ALERT SERVICE BULLETIN

Checking of the correct positioning of sealing plug in ignition housing for ROTAX® Engine Type 912 i (Series)

ATA System: 24-20-00 Internal generator

Fig. 1
Sealing plug in ignition housing

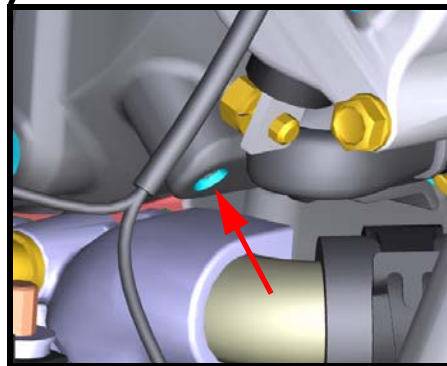
Field observation has shown that in isolated cases the sealing plug (see Fig. 1) was not pressed to its correct seating position in the ignition housing. In rare cases this may lead to loss of oil and subsequently loss of lubrication which leads to engine stoppage.

Fig. 2
Good/bad comparison of sealing plug position

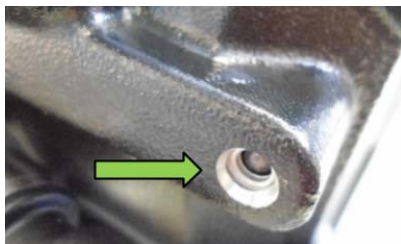
Step	Procedure
1	Check the position of sealing plug in the relevant area of ignition housing assy. See Fig. 2.
2	The sealing plug must show to have been pressed in until the top of the ball is below the edge of the sleeve. See position OK in Fig. 2.
3	If you notice sealing plug position is OK, then there is no need for further procedures. NOTE: If you notice sealing plug position is NOT OK, then see section 3.2.
